ST. TAMMANY PARISH

Addendum No.: 1

Bid#: 24-43-2

Project Name: Brewster Road Sewer Consolidation

SHEET NO.
10PP-05

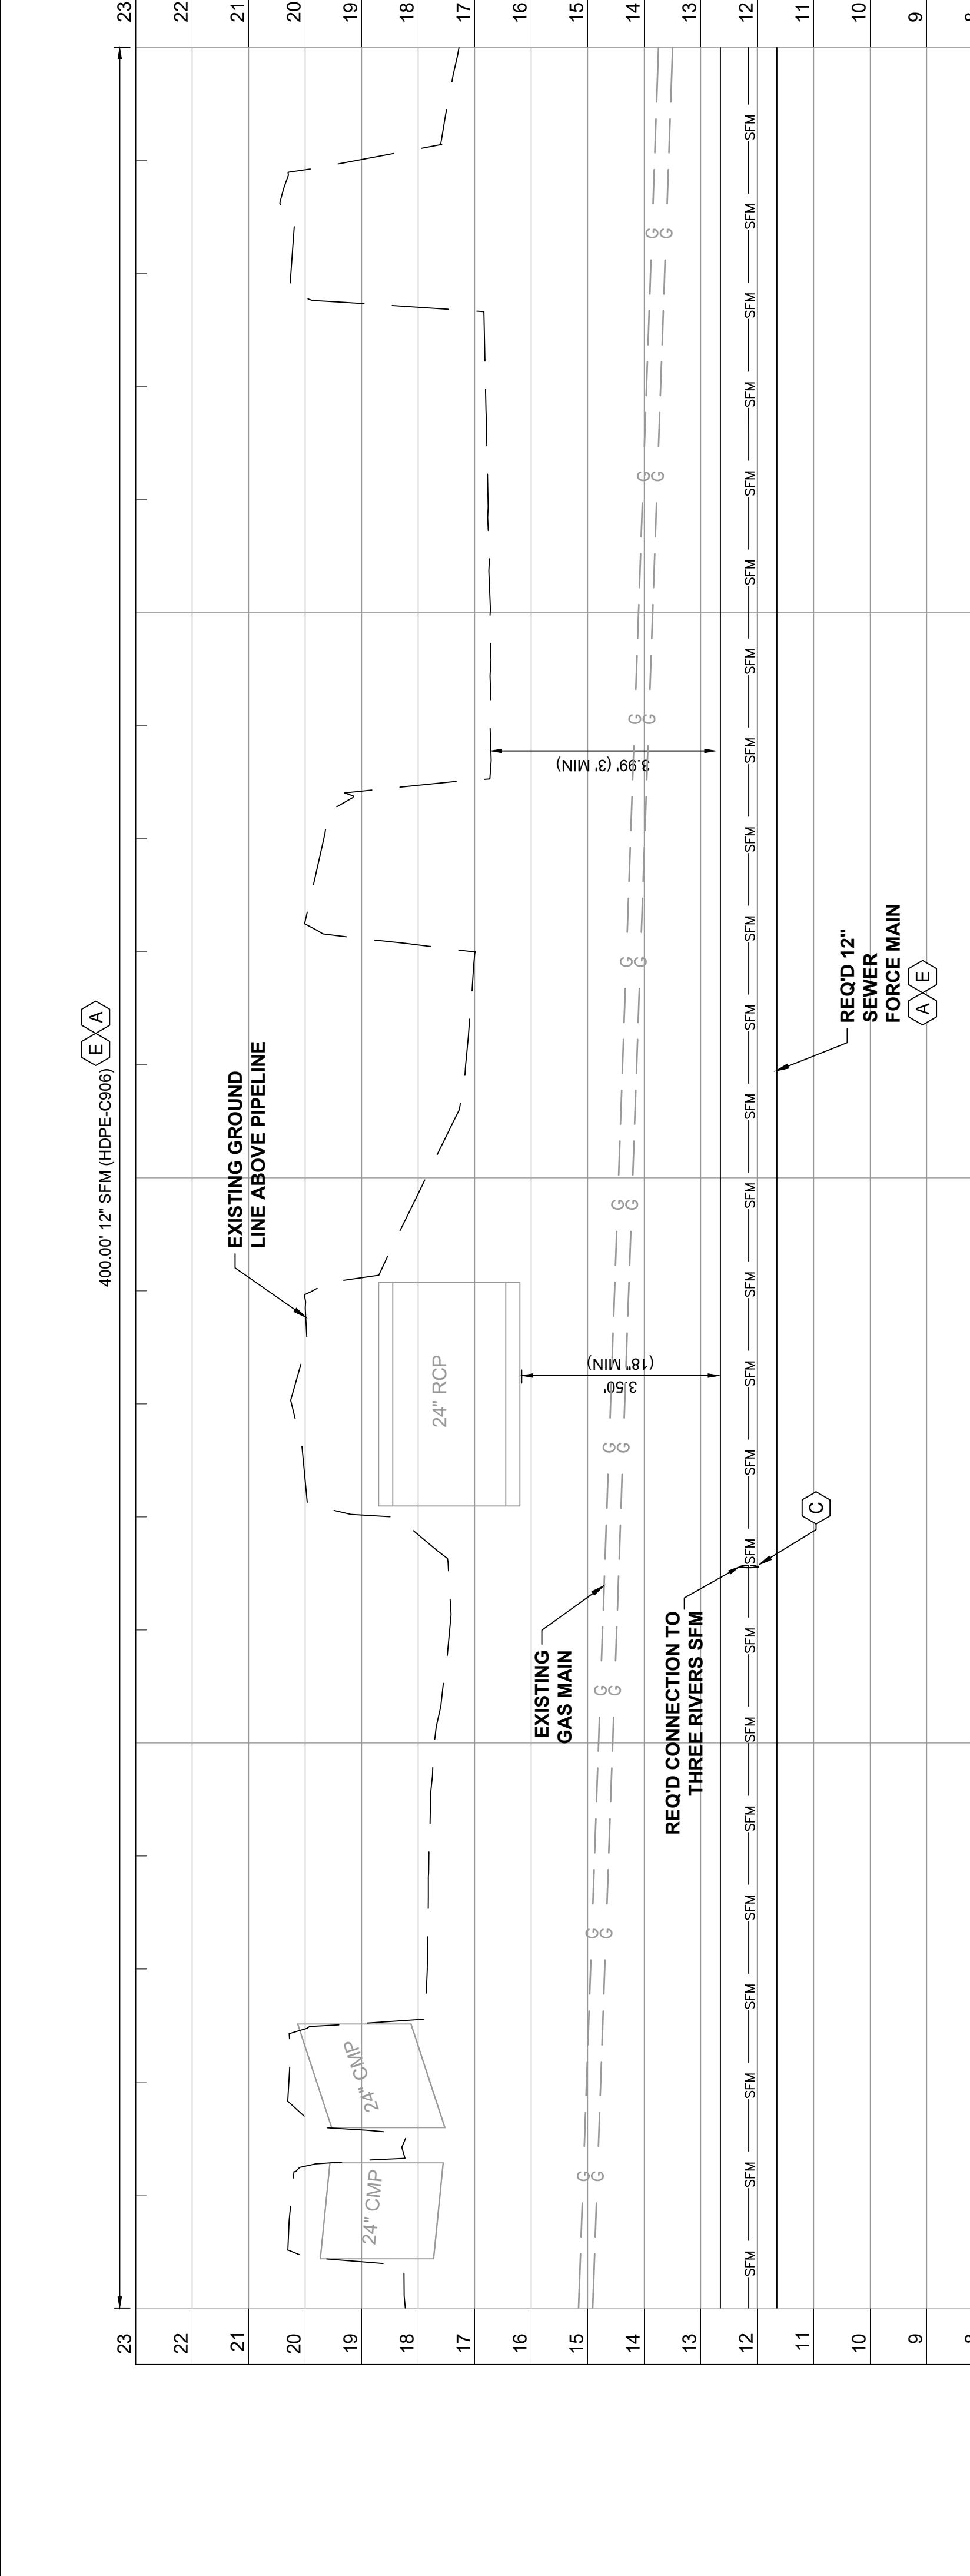
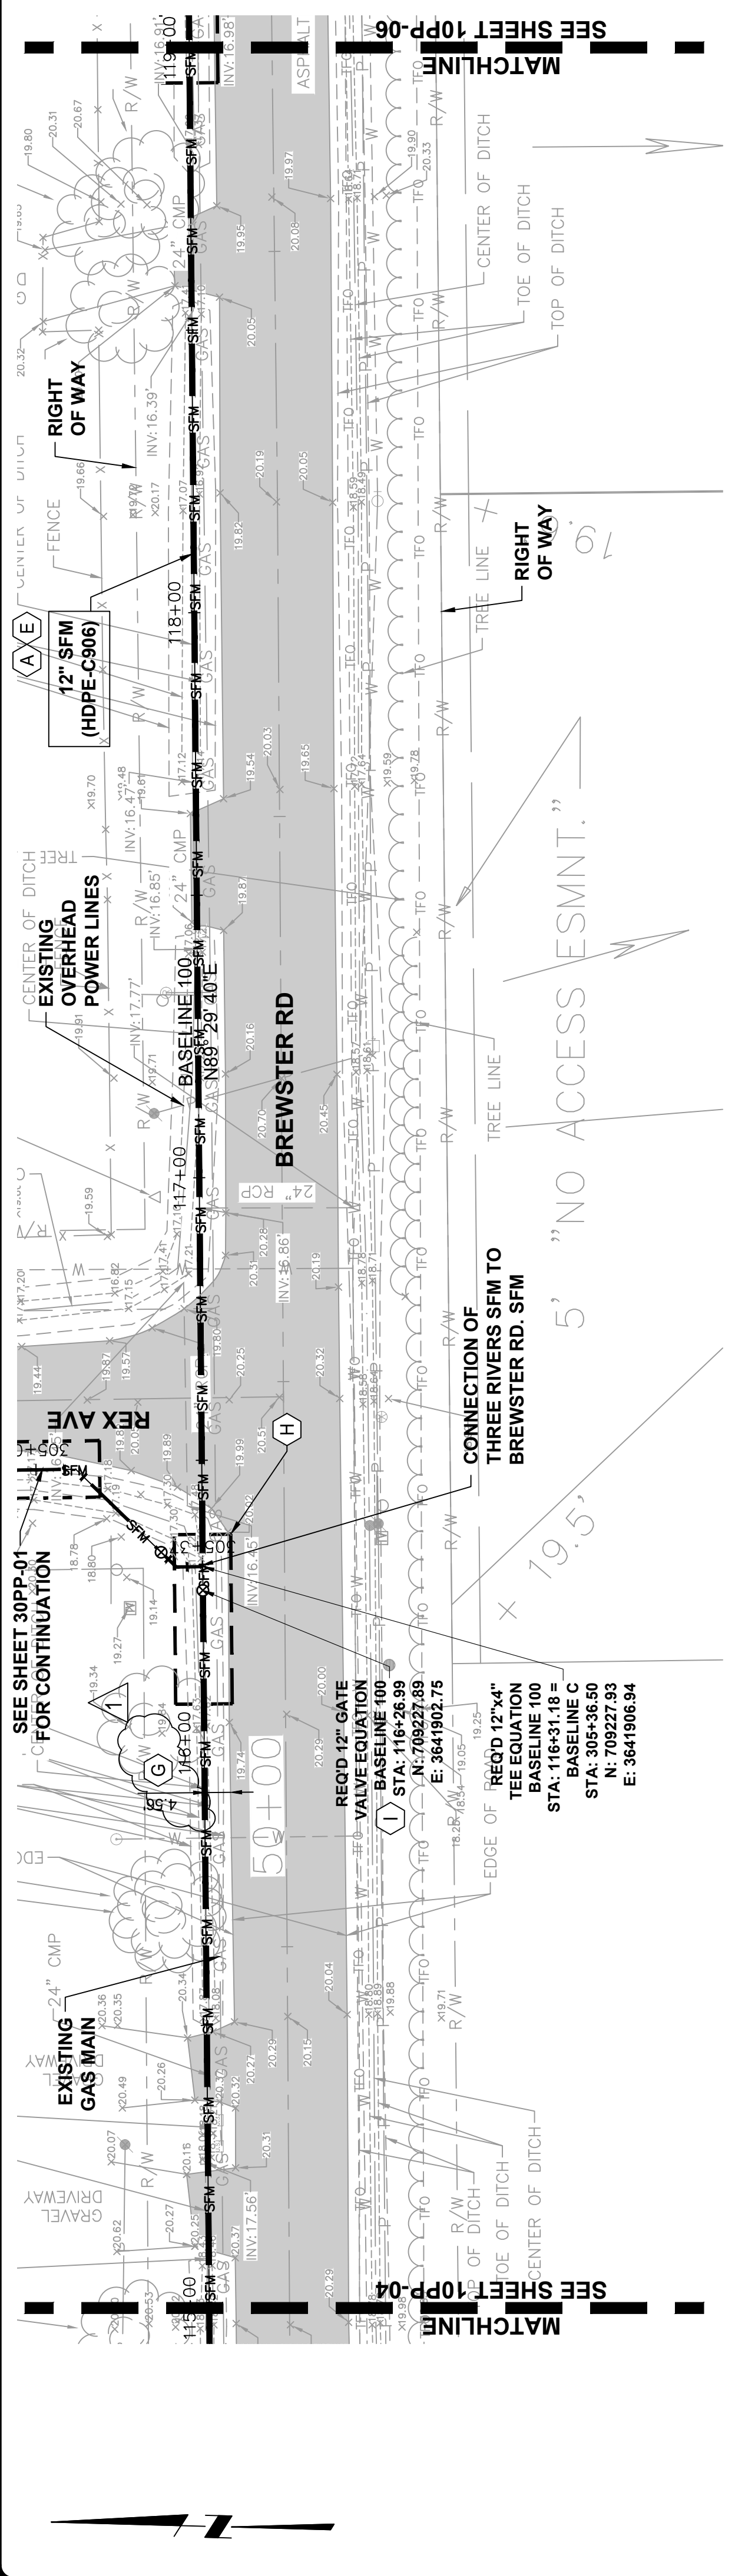
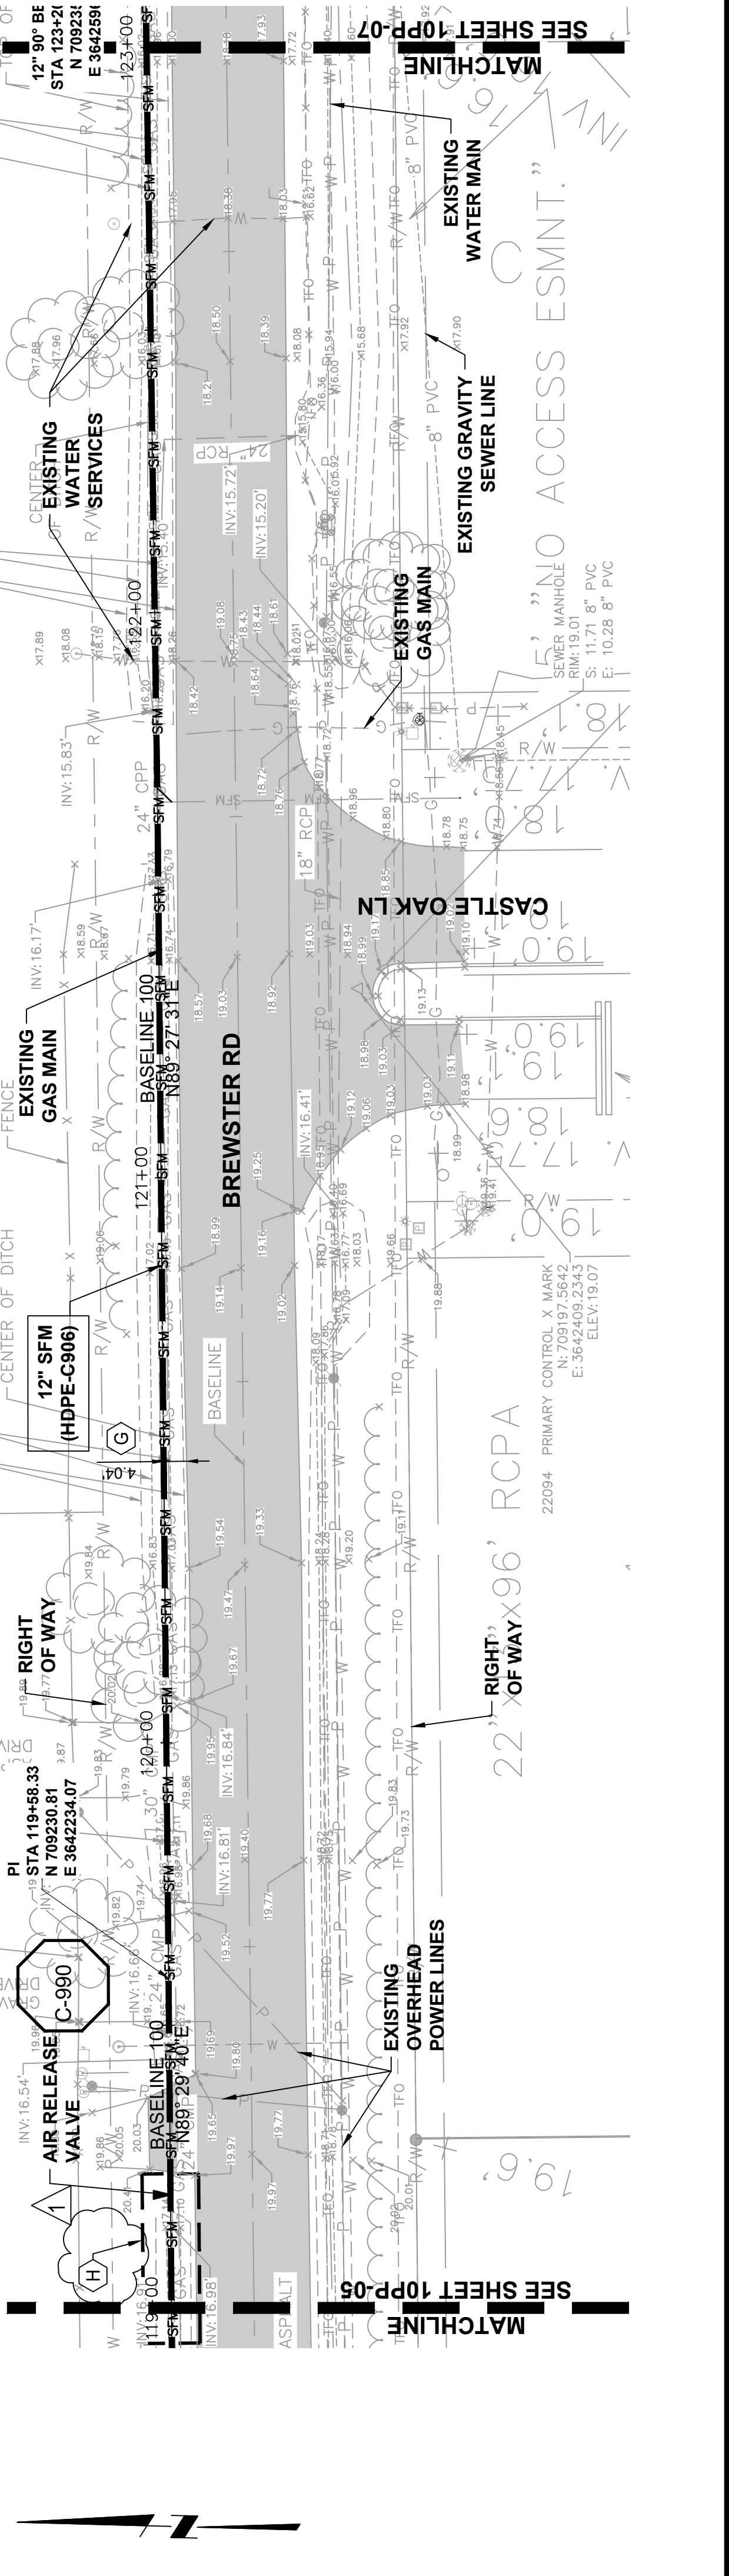
5. Changes to Contract Drawings:
- a. DELETE Drawing 10PP-05 and REPLACE with the attached REVISED Drawing 10PP-05.
 - b. DELETE Drawing 10PP-06 and REPLACE with the attached REVISED Drawing 10PP-06.
